Product Change Notification - 2021/06

Product Line:	speakON	Part No:	NL2FX
Piece Part:	Insert	Part No:	1012323
Engineering Change Notification:	2020-0487	Date:	24.03.2021
Comments:			
Affected products:	NL2FX		
First Shipment of Modified Product:	O09

Engineering Change Notice

Change 2020- 487

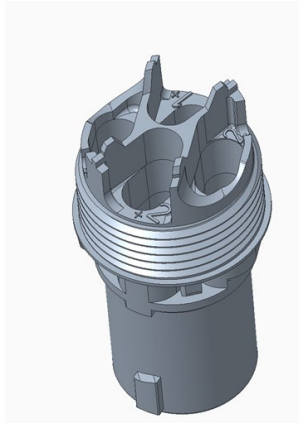
- Strengthened latching area (picture 1.b)
- V-0 material (Material: Polyamide (PA 6.6), Flammability: UL 94 V-0)
- Not combinable with right angle kit LRX any more
